Subject: RE: Followup Regarding Extraction Wells Beneath New Building for 245 8th Street, Oakland

Remediation Project

EXTRACTION WELL PIPING PLAN (BELOW BUILDING FOUNDATION)

245 8TH STREET OAKLAND, CALIFORNIA

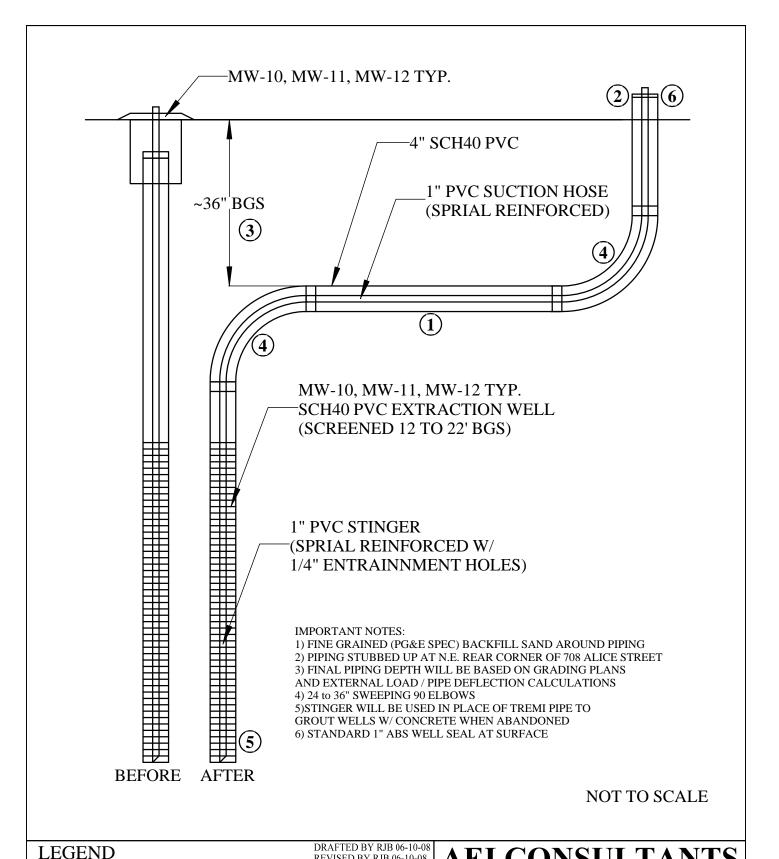
Hi James, I just wanted to email you a site map and piping plan regarding the message I left you this morning about leaving three (3) monitoring/extraction wells (i.e., MW-10, MW-11, and MW-12) in place beneath a proposed building at 708 Alice Street. The wells were installed for the monitoring and remediation of a fuel release from the 245 8th Street property. The 708 Alice Street property has been vacant for many years now, but building plans have been approved and the owner is going to build on the property. We have discussed this situation with our case manager Mr. Jerry Wickham at Alameda County Environmental Health (ACEH).

Basically, we have a large groundwater plume (>150-feet) extending from onsite to somewhere beyond 7th Street and a potential vapor intrusion concern at nearby residences. We've been actively remediating using onsite wells since June of last year and offsite wells at 708 Alice Street since November of last year. Rather than abandoning the wells, which would make the cleanup much more difficult and costly,

we would like to leave MW-10, MW-11, and MW-12 in place beneath the proposed building as described in the attached drawings. We have designed the wells and piping network in such a way that we'll still have the ability to effectively seal the wells with a cement slurry using the 1" extraction hose, called a "drop tube" or "stinger", as a tremi-pipe. Please refer to the attached piping plan for more details.

Your proposal seems fine. I don't see any problems with doing this.
